UNITED STATES PATENT AND TRADEMARK OFFICE

APPLICATION NO.	FILING DATE	FIRST NAMED INVENTOR	ATTORNEY DOCKET NO.	CONFIRMATION NO.
10/533,990	05/04/2005	Andreas Wunderlich	040085.00004	2585
26710 7590 09/14/2007 QUARLES & BRADY LLP 411 E. WISCONSIN AVENUE SUITE 2040 MILWAUKEE, WI 53202-4497			EXAMINER MITCHELL, KATHERINE W	
			ART UNIT 3677	PAPER NUMBER
			MAIL DATE 09/14/2007	DELIVERY MODE PAPER

Office Action Summary

DETAILED ACTION

EP 0 501 850 A1

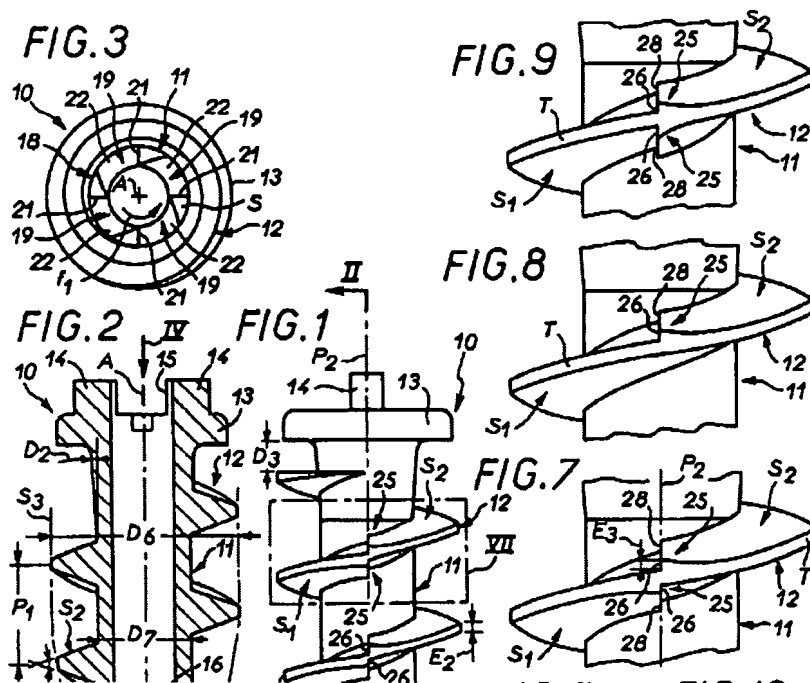
Examiner is very unsure of what is being claimed, but as best understood, Auger teaches in the Figures and abstract a screw capable for use on hard materials, with a shaft, head at one end, tip, and a thread with cutting teeth having equal but opposite sides that are laterally offset to opposite sides of the thread's longitudinal centerline. (see new matter above). There are a series of cutting teeth formed along at least one half turn of the thread—the series is formed by considering multiple half turns to include multiple teeth. As best understood, noting that paragraph [0008] is the only disclosure of a sawtooth, examiner considers Auger Fig 1 to be a sawtooth profile, with teeth disposed to opposite sides of the longitudinal centerline (see new matter above). The thread has a flattened crest forming a narrow face (T) with edges 28 extending across it, and there are a plurality of narrow faces along at least one half turn – the plurality is along several turns, which are at least one half turn, and there are cutting edges. The transverse leading edges on at least one side are roughly radially disposed and extend all the way down to the shaft (Fig 10, and Fig 6, not copied, best shows this). The thread has 2 sides with alternating protrusions and notches (Figures, esp. 8,5,10) The teeth are along a longitudinal centerline of the thread and have leading edges as described, and the figures show cutting teeth edges disposed along radii all the way down to the screw shaft. (Figures). The included angle between sides S1 and S2 of the thread are in a range of 20-30 degrees at the portion due to penetrate the drilled hole wall. The included angle between sides S1 and S2 of the thread are in a

range of 45 to 60 degrees over the transition zone immediately adjoining the shaft. Fig 7 and 8 show the teeth (on upper vs lower sides) offset from one another by the width of their face. The set of teeth vary over the shaft length- some are on one side, some are on the other, some have “double” teeth (fig 9 and 7), which is varied.
